RE: SES Solar One Project
Applicant's Responses to CEC and BLM Requests During the September 16th Workshop

Subject: **Additional Data Requests Made during the Issues Resolution and Data Request Workshop - Air Quality**

Subject: **Additional Data Requests Made during the Issues Resolution and Data Request Workshop - Land Use**

**APPLICATION FOR CERTIFICATION
For the SES SOLAR ONE PROJECT**

PLOT PLAN AND FENCELINE SOLAR ONE PROJECT		
CREATED BY: LG	DATE: 08-12-09	FIG. NO:
PM: WM	PROJ. NO: 27658189.40002	5.2-2

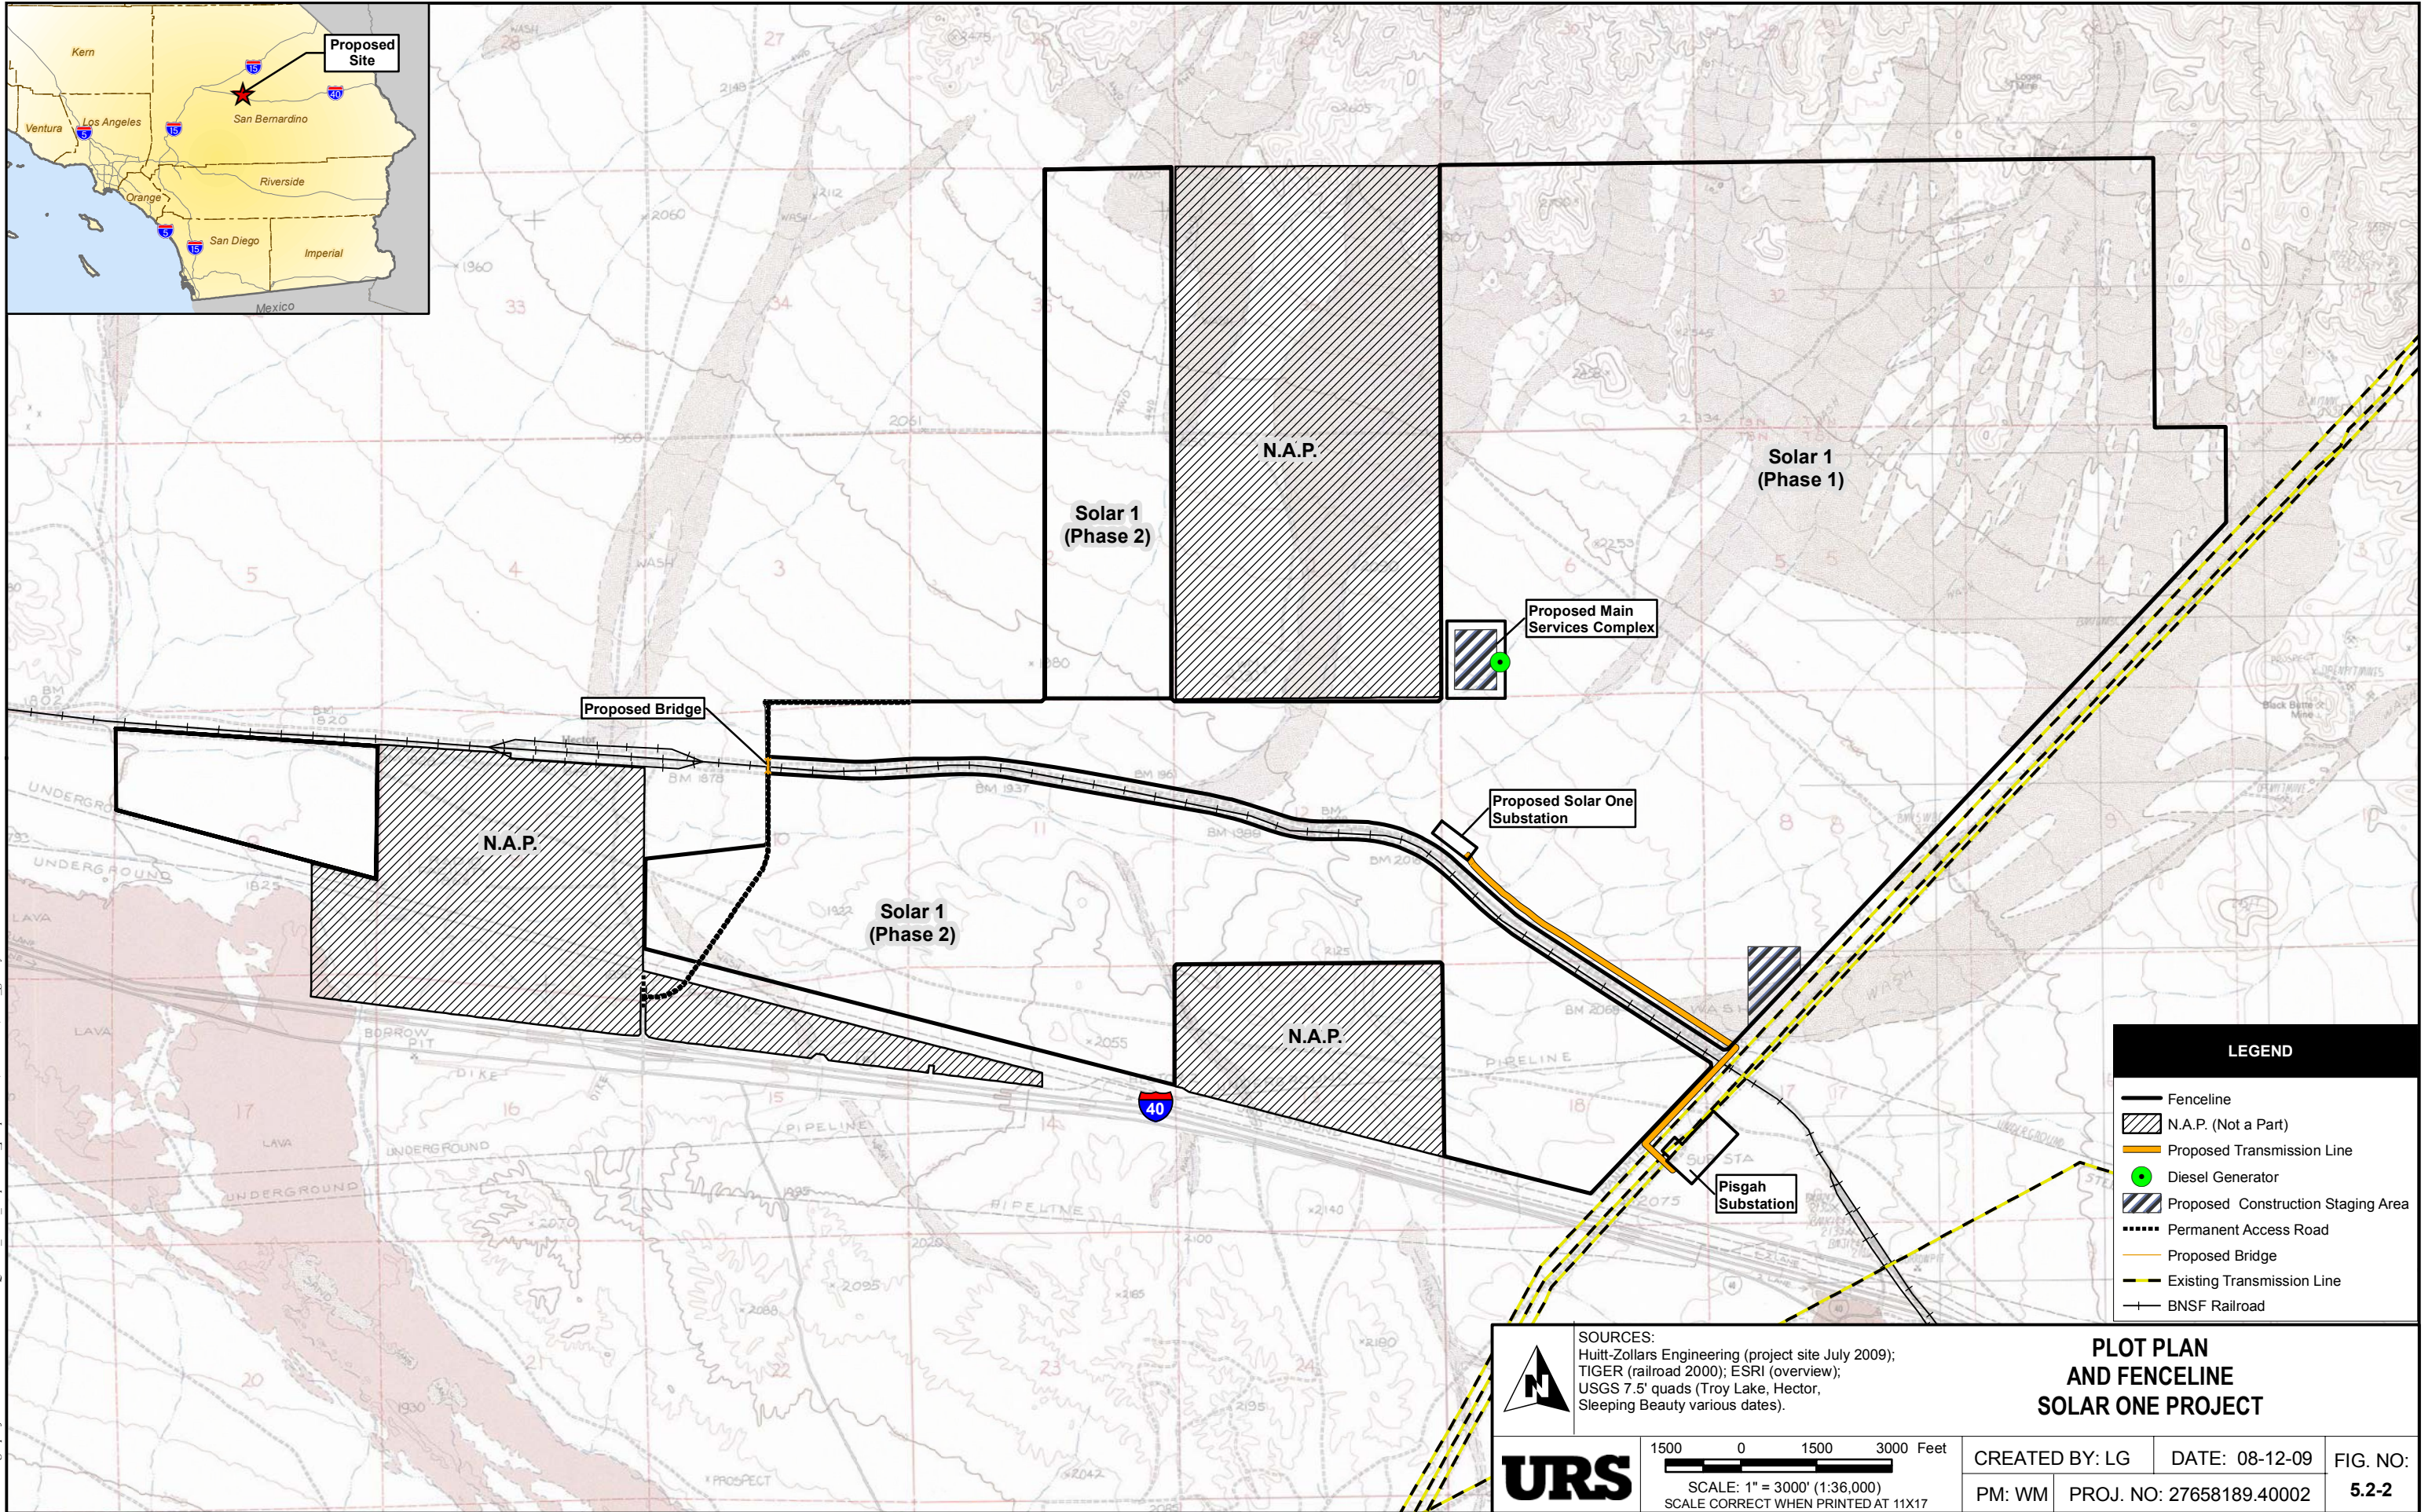
In response to a request that the Applicant provide additional information on the planned use private parcels located in the south western portion of the Proposed Solar One Project, URS, on behalf of the Applicant, submits the following response:

Please find a site plan, docketed on August 31st, 2009 in response to CEC and BLM Data Requests, submitted behind this memorandum. As is shown in the figure, development is not proposed for those private parcels. Further, while the private parcels are within the Project boundary, they will not be fenced, nor will access to the parcels be inhibited as a result of Project development.
